APPEAL SUMMARY

Appeal ID: 26329	Project Address: 1021 SW 4th Ave
Hearing Date: 12/8/21	Appellant Name: Glen Pak
Case No.: B-004	Appellant Phone: 5032249656
Appeal Type: Building	Plans Examiner/Inspector: Maureen McCafferty
Project Type: commercial	Stories: 9 Occupancy: B, A-2, A-3, S-2 Construction Type: I-B
Building/Business Name: Historic Multnomah County Courthouse	Fire Sprinklers: Yes - Entire Building
Appeal Involves: Alteration of an existing structure	LUR or Permit Application No.: 19-245664-LU
Plan Submitted Option: pdf [File 1] [File 2] [File 3]	Proposed use: Office, Retail, Event Space

APPEAL INFORMATION SHEET

APPEAL DECISION

View of Existing Stair

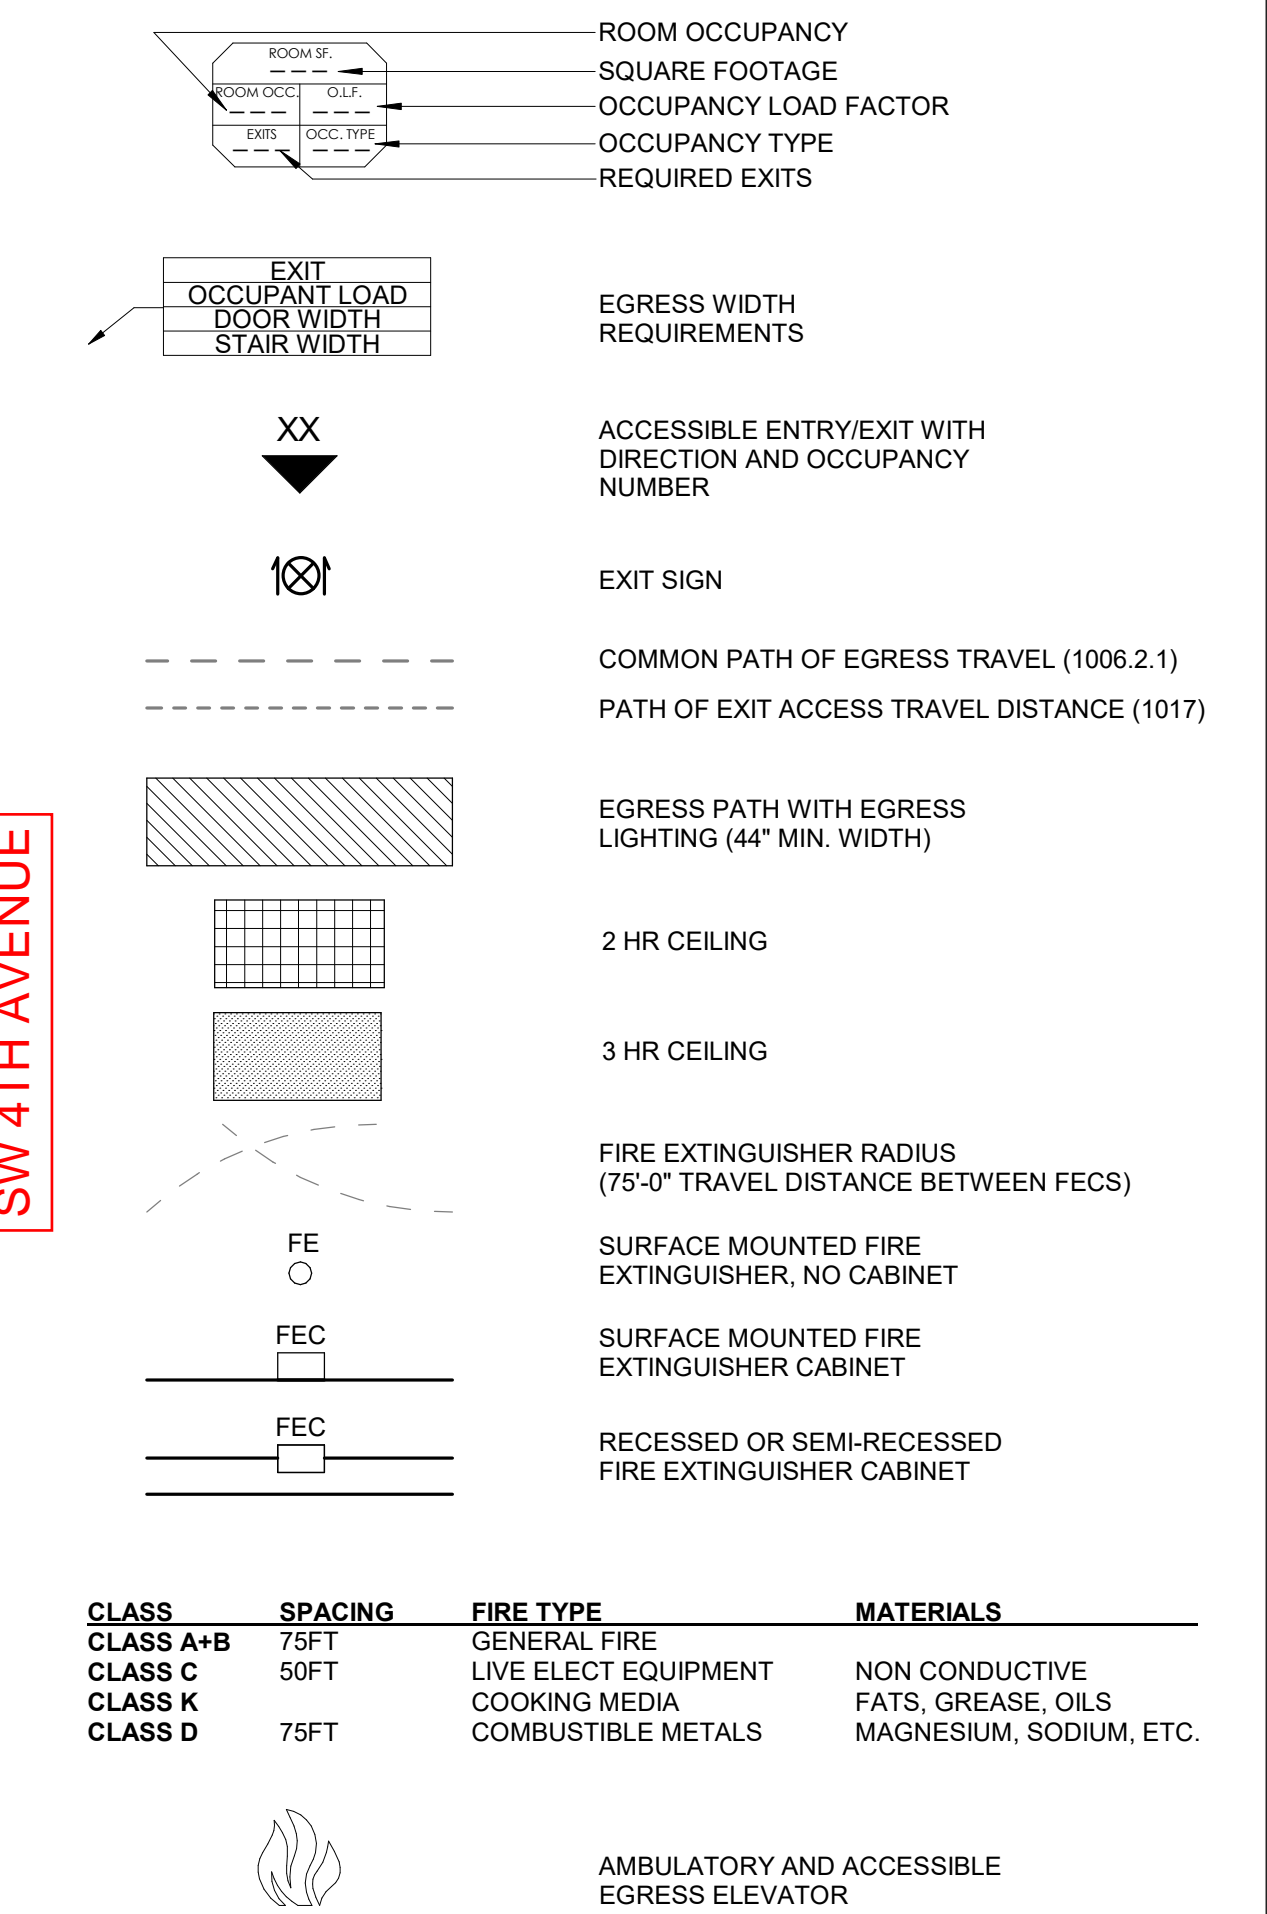
Code Section	1009.3.1 Exit access stairways
Requires	Exit access stairways that connect levels in the same story are not permitted as part of an accessible means of egress.
Code Modification or Alternate Requested	Approval that an existing stair on the Ground Floor can be utilized as a means of egress.
Proposed Design	The adaptive reuse of the Historic Multnomah County Courthouse maintains much of the original historic character of the building on both the exterior and the interior. An existing entry/exit door on SW 5th Avenue is being maintained as part of the approved Historic Land Use review. There is an existing historic stair on the interior side with a difference in elevation from street to ground floor of approximately 5'-4" that is intended to remain. No alterations are proposed to the stair design or the historic finishes of the staircase as part of the preservation efforts of the project. The sequence leading to the entry/exit doors are not required to be rated but the area will be fully sprinklered. The existing stair has the appropriate width to handle the number of occupants as shown on sheet G101. Updated door hardware will be added to the existing doors to allow them to comply with egress requirements.

1. Existing exit access stairway that connects levels on the same story to be used as the 2nd required accessible means of egress from the first floor: Granted as proposed.

G101

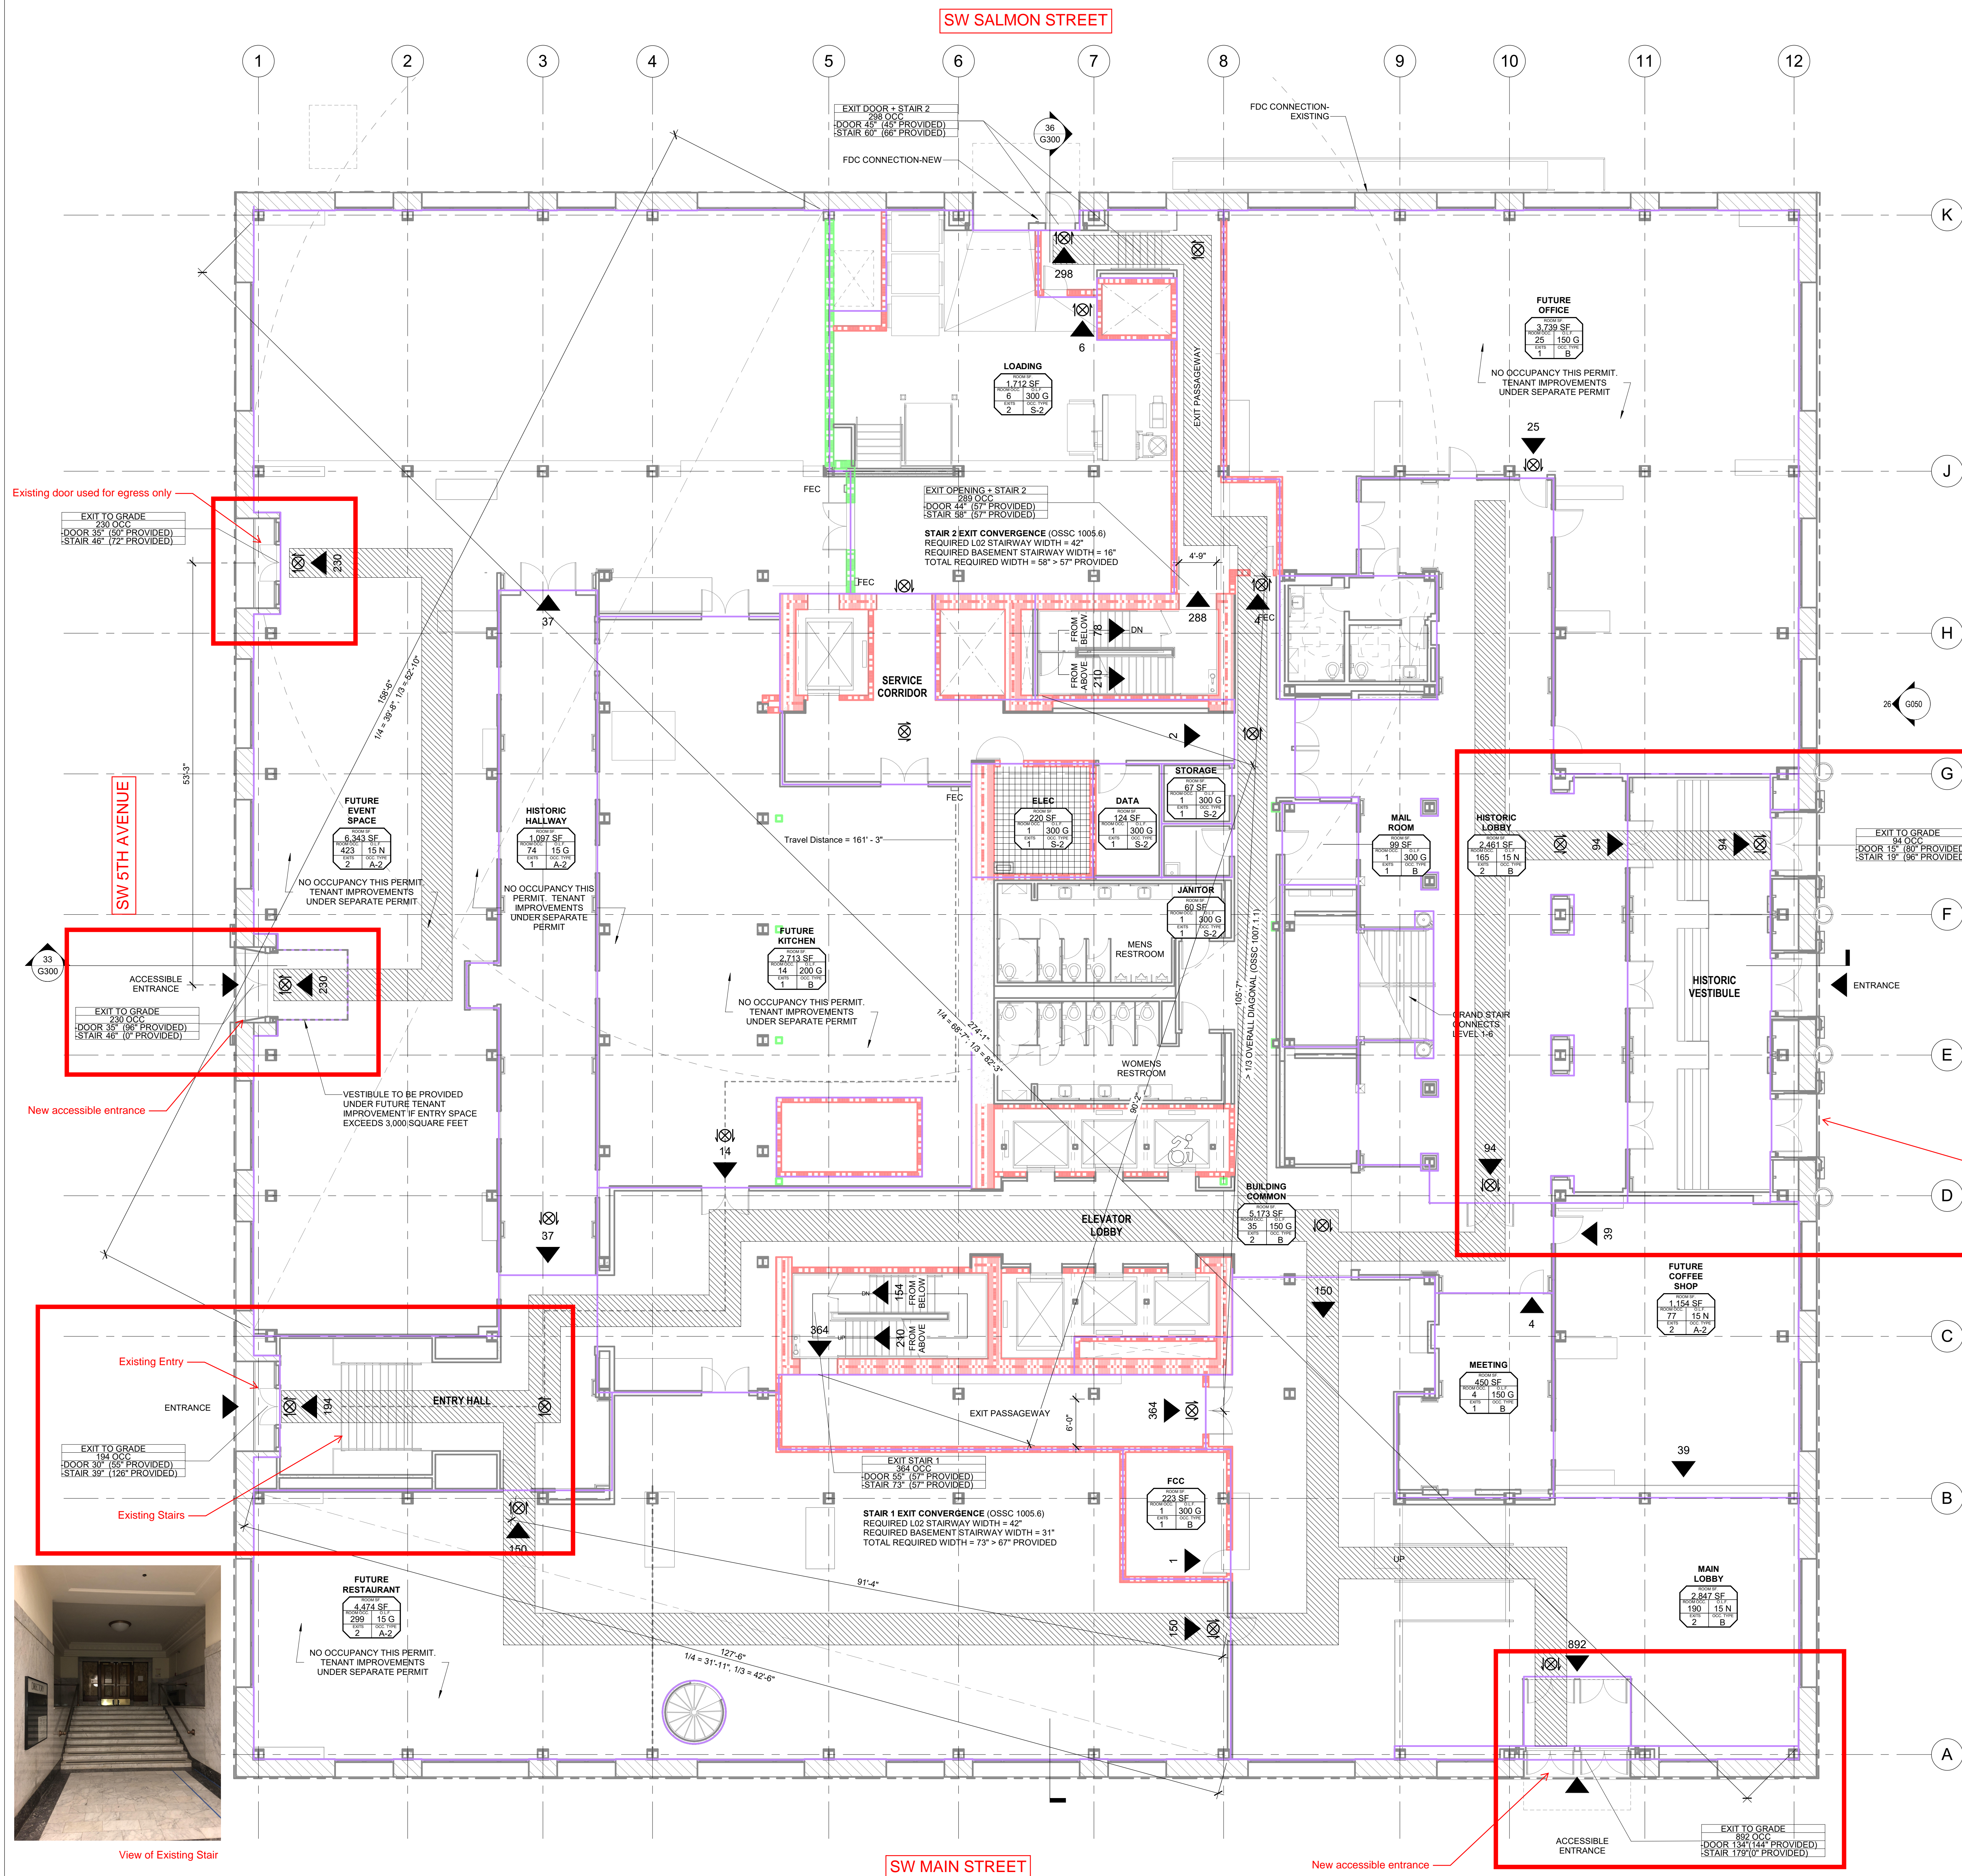
Reason for alternative	These doors are required to satisfy egress conditions of the Ground Floor level. Each door leaf is smaller than the required 32 inch requirement by code, but the combined opening provides a 55 inch opening that satisfies the egress requirement of 30 inches that these doors need to serve as shown on G101.
-------------------------------	---

2. Existing double door without mullion with minimum required opening width of 32 inches to be provided by the 2nd door: Granted as proposed.
